**5.0 Design Development**

### 5.1 - Discussion with Camden Council Design Officer 22.09 2010

Fig - 5.2.2 - The Entrance / Fence and Podium

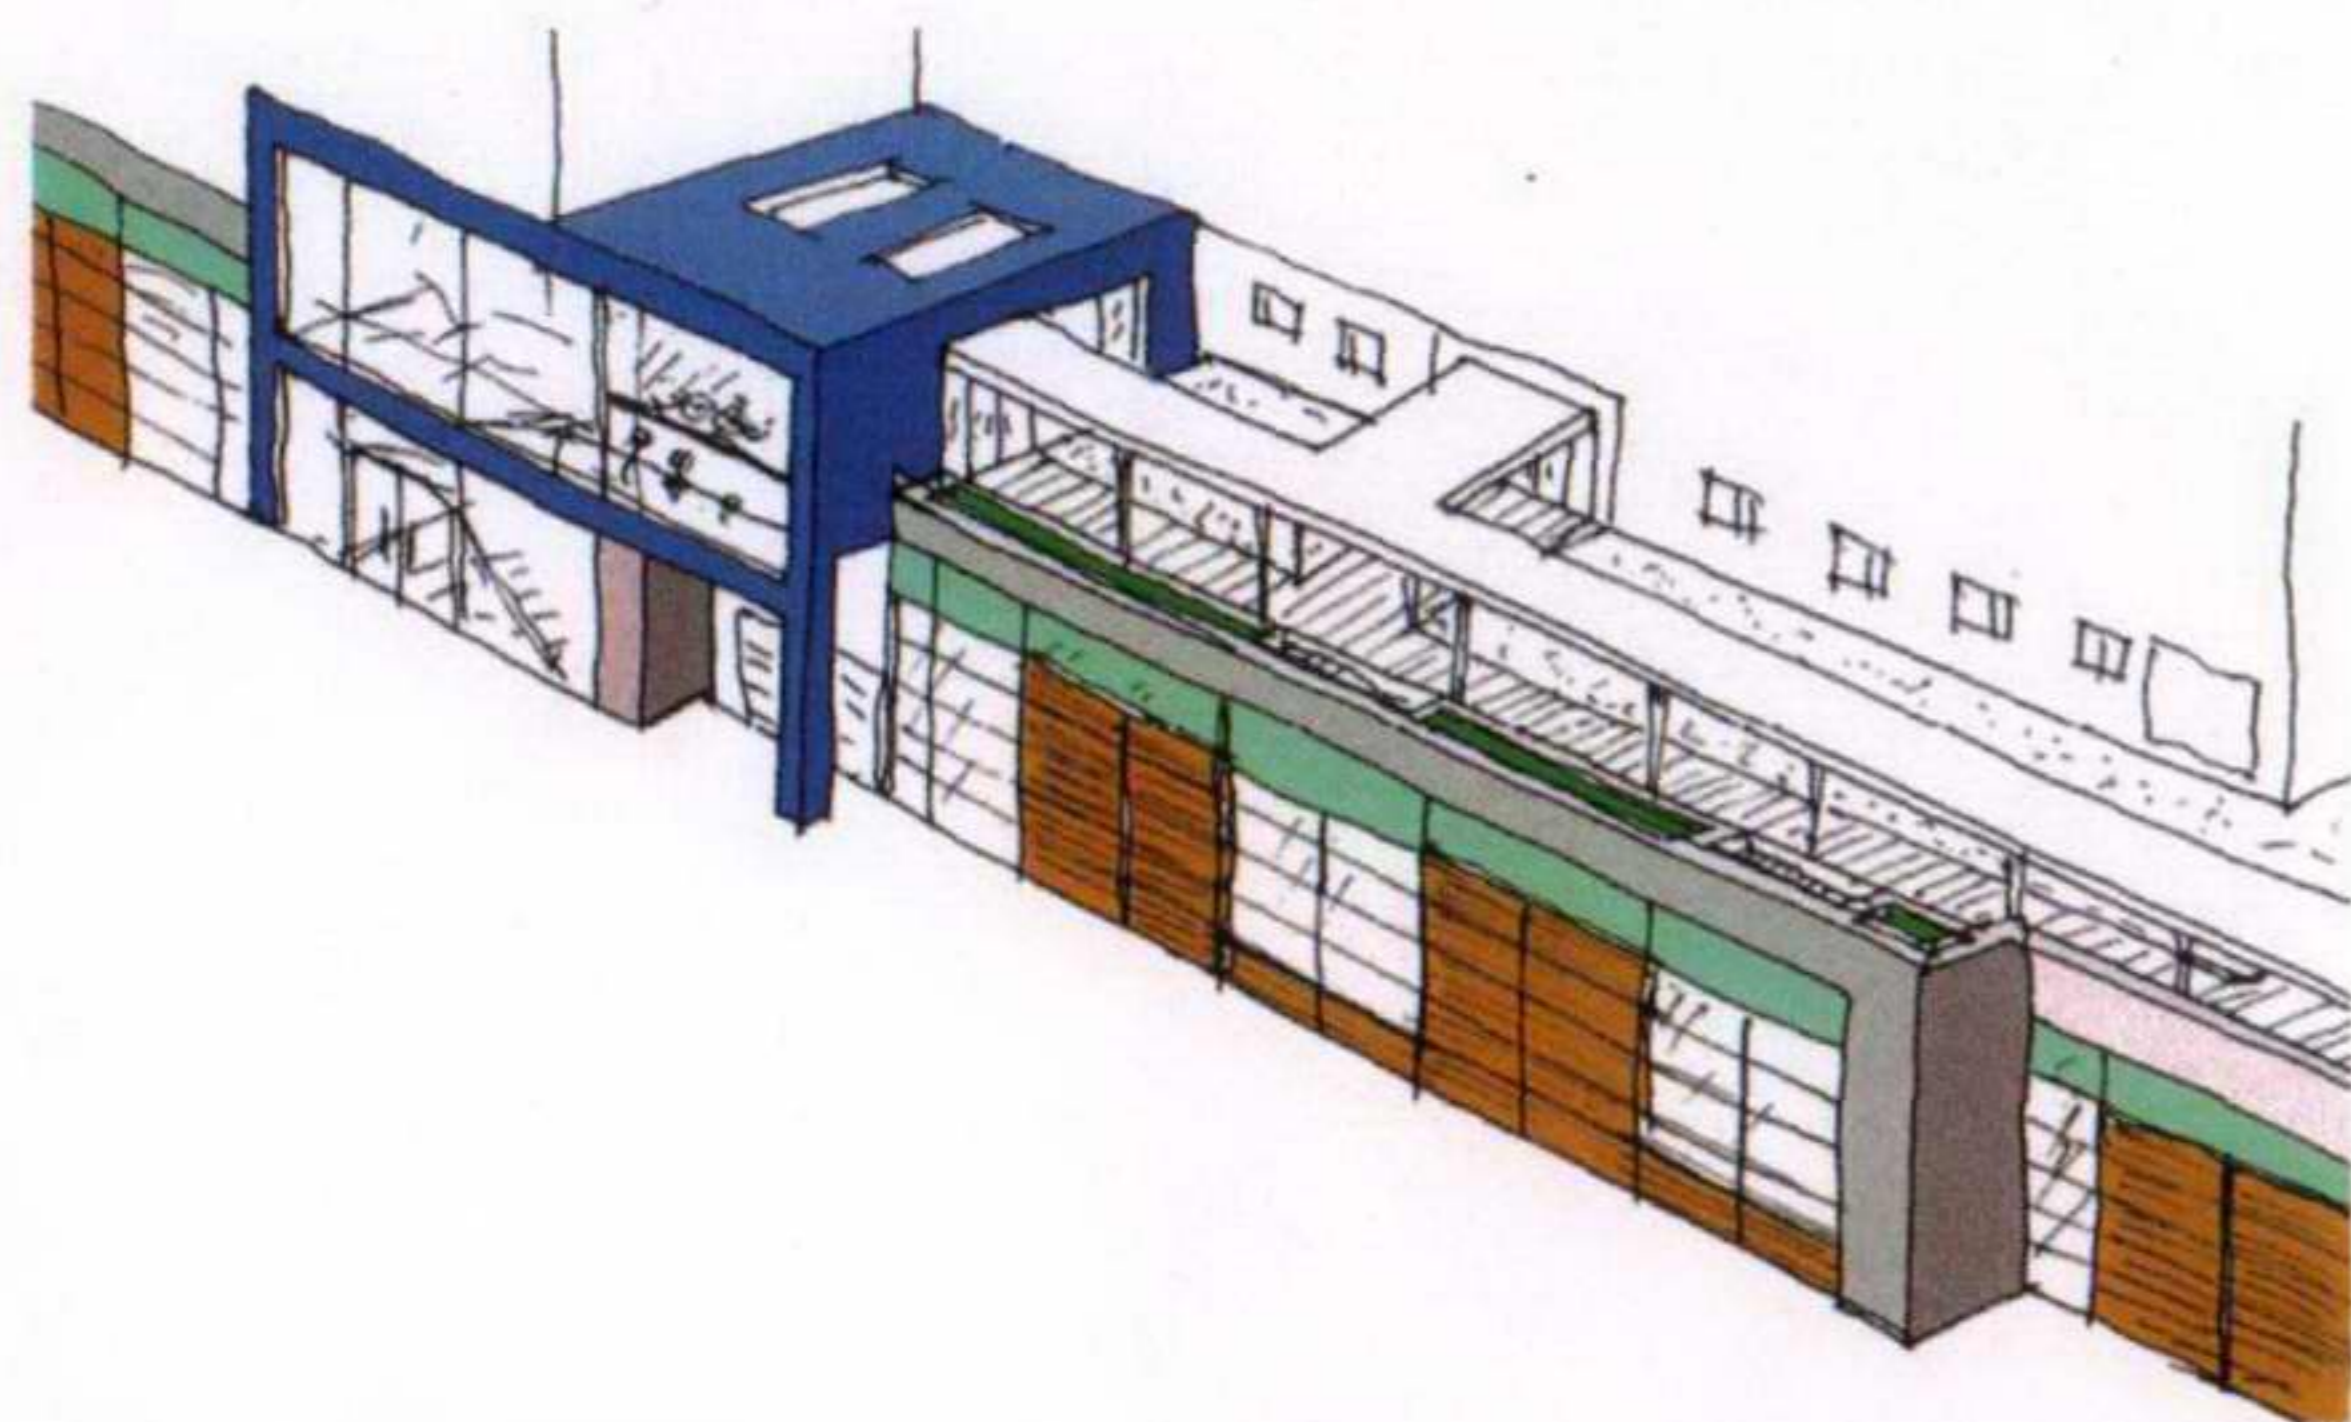
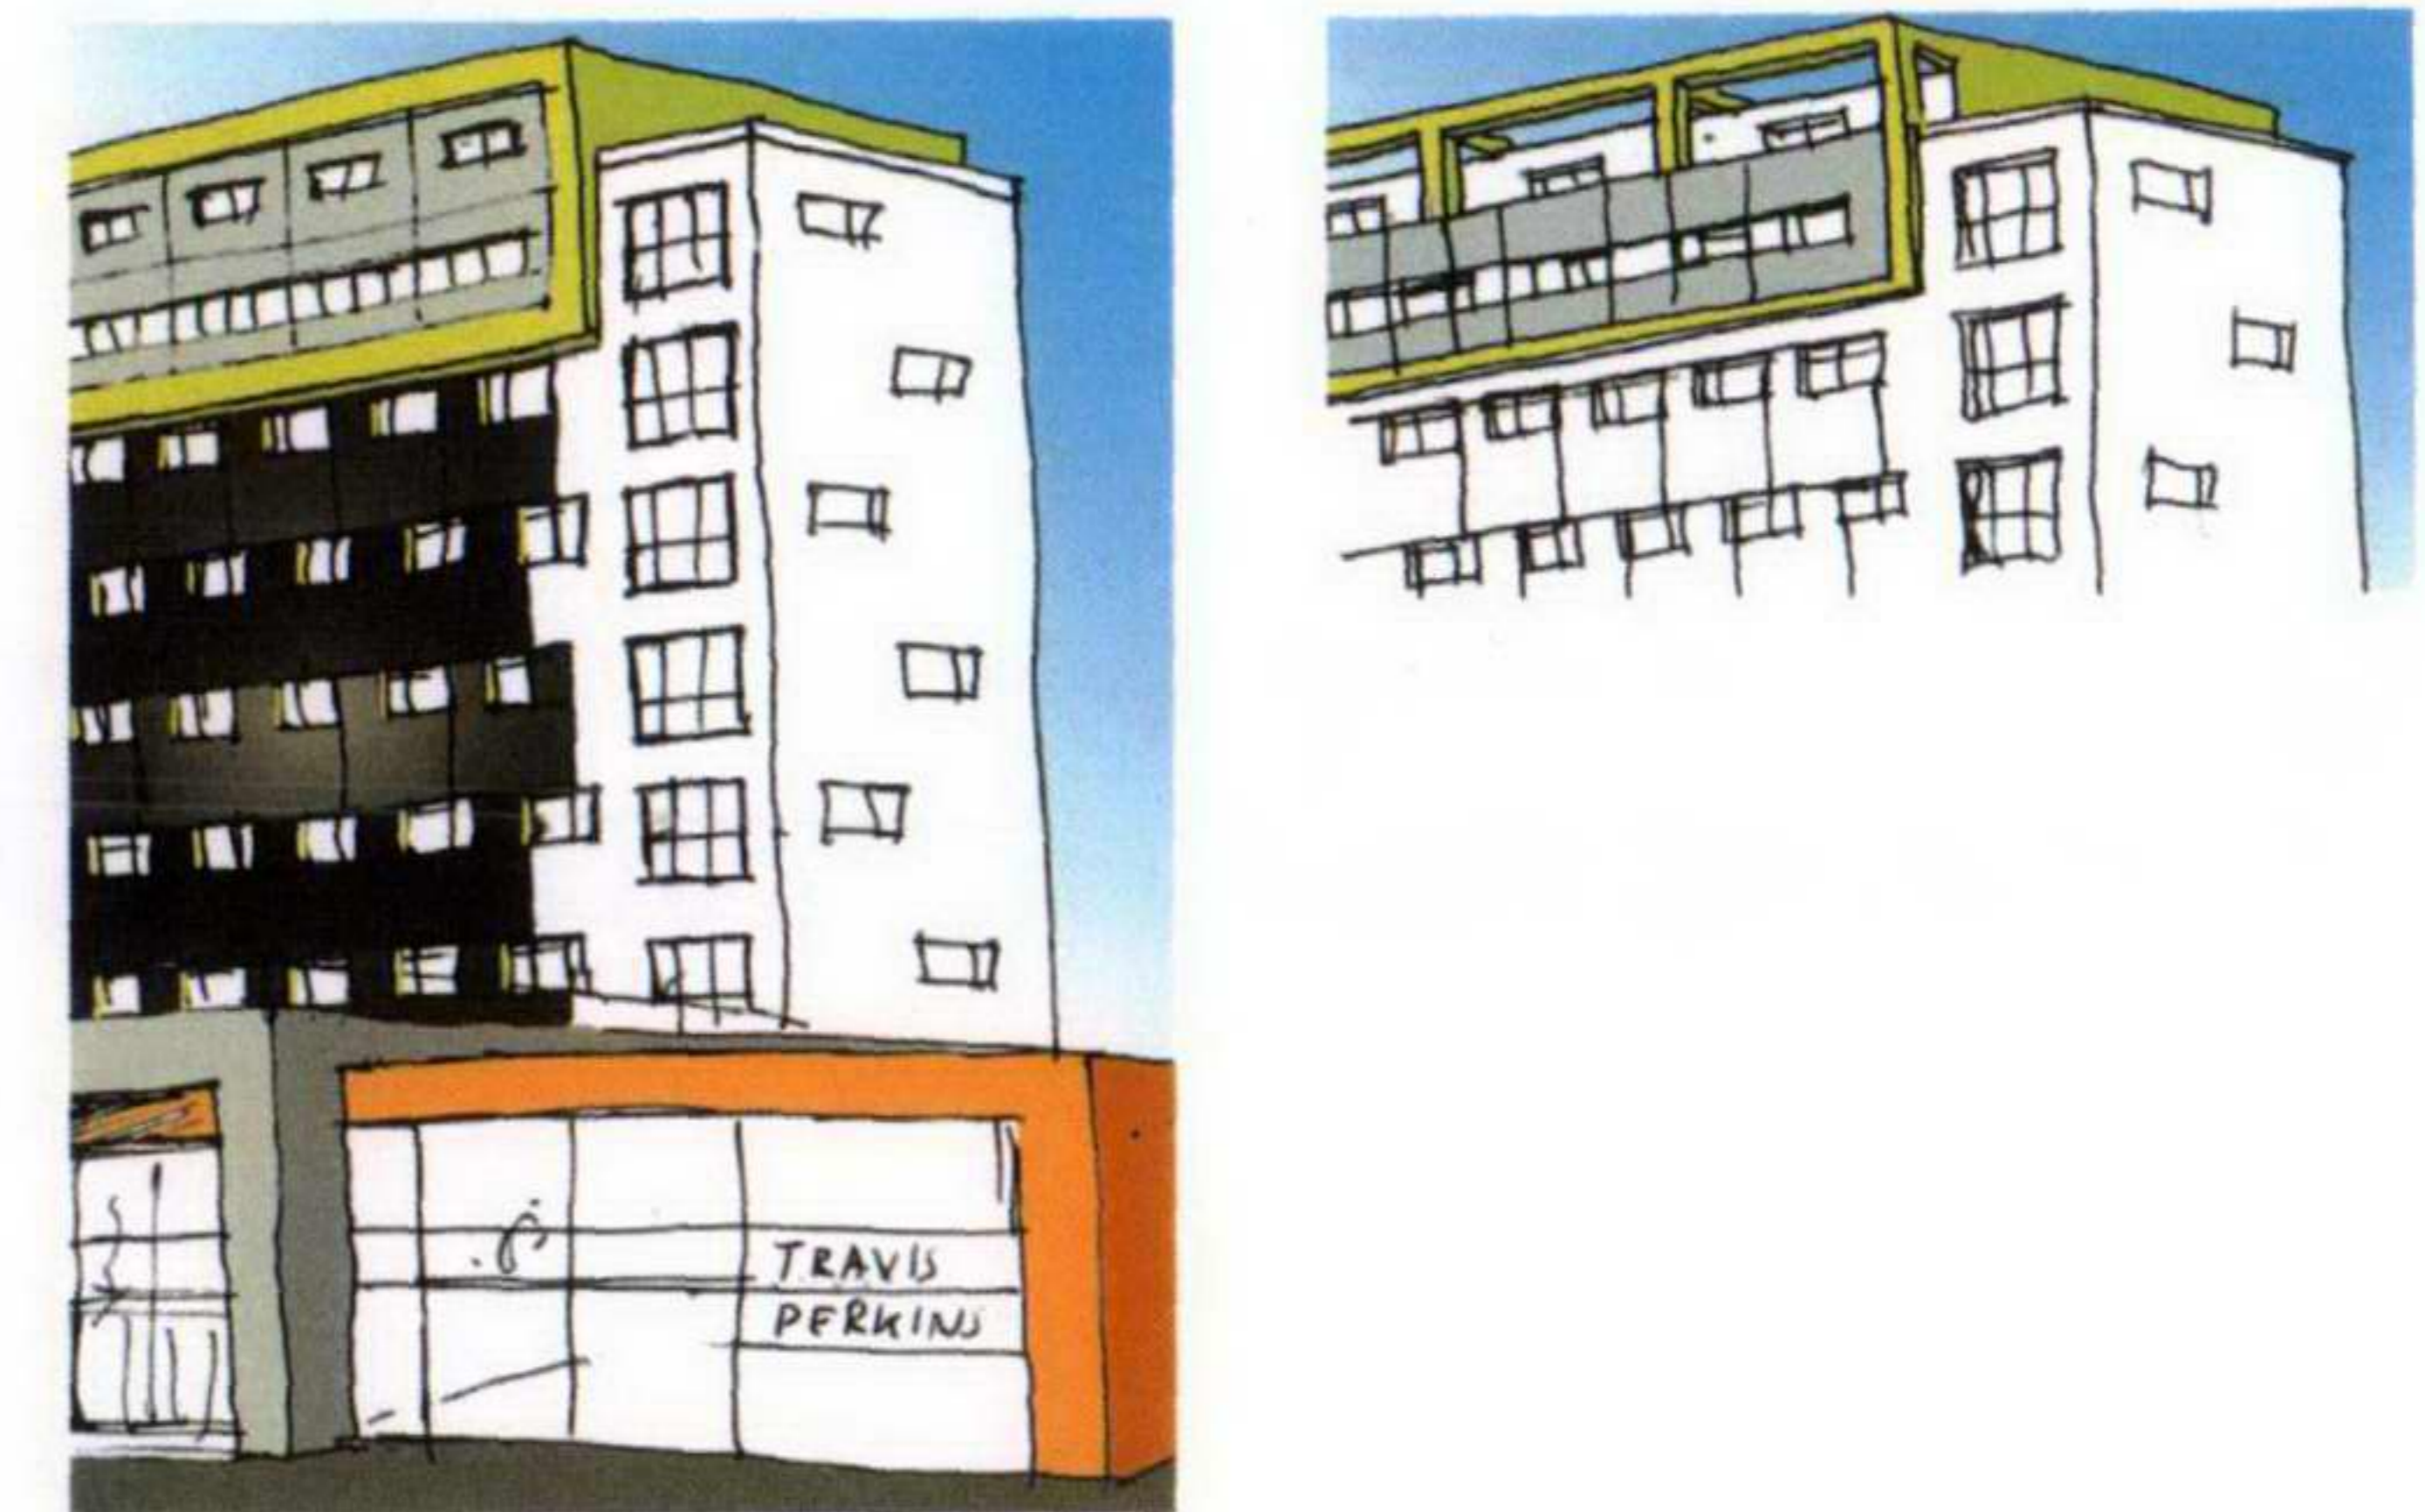
- The overall mass and concept of the design was acceptable.
- The principle of the wall to Travis Perkins and the entrances was acceptable but requires more detailed design before the final planning application. More openness to the operations behind was preferred.
- The stepped design of the podium deck was agreed.
- The new location of the main entrance was discussed and agreed as positive.
- The elevations were discussed and it was agreed that more work would be put into their design. Positive elements were the attempt to break up the mass with the box like structures. The shifting tessellated façade was less welcome, but the principle of how we were trying to express the concept was encouraged.
- More investigation into materials is required with a suggestion to investigate more traditional materials such as brick cladding, to be more contextual and solid.
